## TECHNICAL UPDATE

# 6

Number September '82

### 6.5 RIVETS IN PJ PLUGS

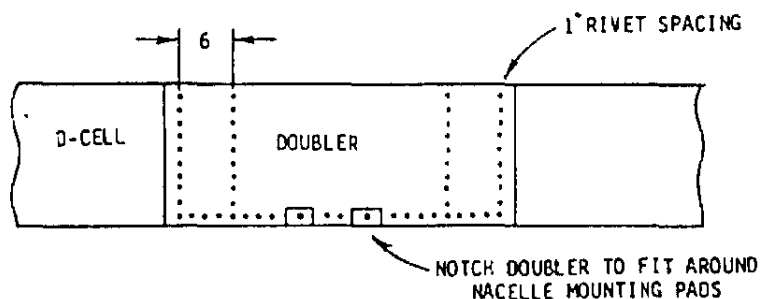
Although calculations and testing have shown that one rivet would be sufficient to hold the PJ plugs into the control pushrods, we use two rivets in each to provide a safety factor in the order of ten-to-one for normal control surface loading. However, it may be possible in the event of a mishap (such as an aircraft being blown over by severe winds while tied down) to apply stresses beyond the strength of the rivets and shear them off. If your aircraft is ever involved in any type of incident which could put abnormal loading on the control pushrods, they should be inspected very carefully before the next flight. Pushrods should also be inspected very carefully if you buy a used aircraft, especially if it has been damaged. If there is any indication that a pushrod could have been overstressed, install an extra rivet in the PJ's for security.

## 6.8 AXLE GUSSETS FOR RUDDER PEDALS

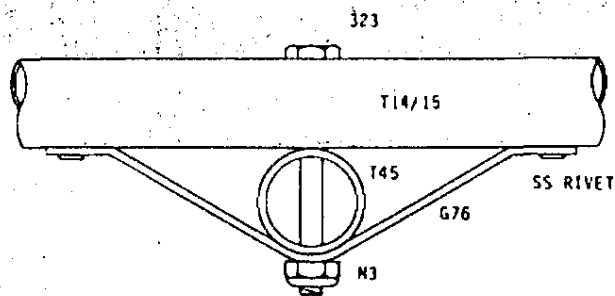
In the assembly manual for the rudder pedal kit, there is a reminder that when one rudder pedal is pushed down, the other one must come up, and therefore you should not attempt to push on both pedals simultaneously. However, for whatever reason, people do occasionally push down on both pedals. While reasonable pedal pressure does not cause a problem, excessive force will bend the two 323 bolts which hold the nosewheel axle to the side tubes. To alleviate this problem, we are now including with the rudder pedal kits two small gussets (G76) to help support the axle. If you have an earlier rudder pedal kit and wish to add these gussets, you can make them yourself from two strips of aluminum alloy .040 to .080 inches thick, 1/2 inch wide and 6 inches long. Bend and install the gussets as shown.

#### 6.10 FRONT FITTING RADIUS

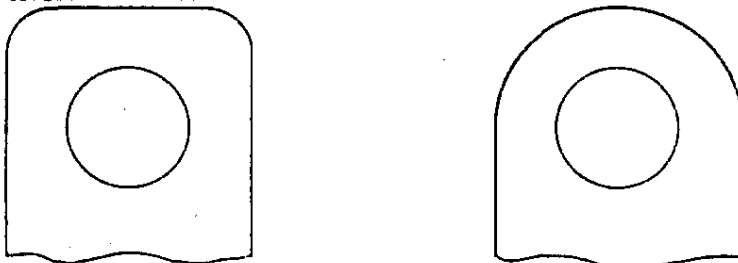
A few kits were shipped recently with front fittings shaped as shown at left below. If you assemble the control system with the fitting as shown, you will probably find that it interferes with the pushrod when you move the control stick to deflect the ailerons.

To work properly the fitting should be cut, filed or sanded as shown at right above.

#### 6.13 ENGINE MOUNT ANGLES

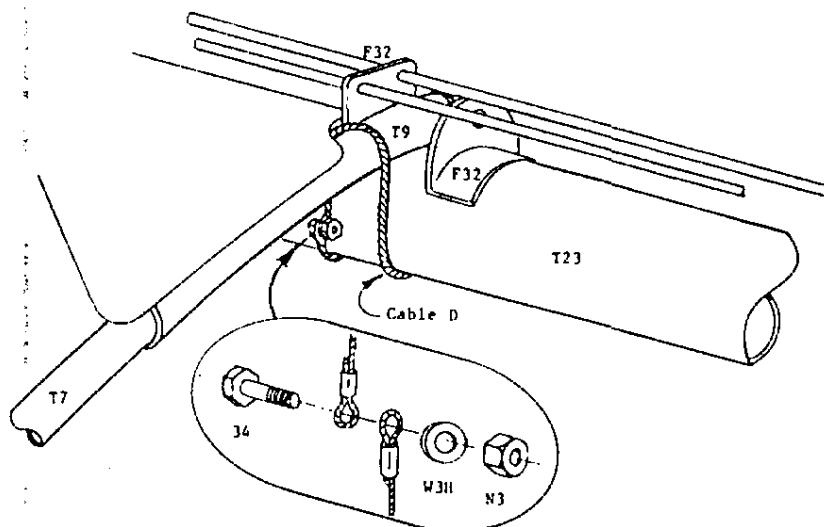
We have received two reports of broken G42 engine mount angles (these are the large brackets which are bolted directly to the crankcase). Although this represents less than 0.2% of the mounting brackets in use and therefore does not indicate a trend, a careful inspection of these brackets should be included in your normal pre-flight walkround. Since we will probably be changing to a different type of mount to accommodate the new recoil starter, we expect to have a few surplus mount angles which we could supply at no charge to anyone who returns a broken one.
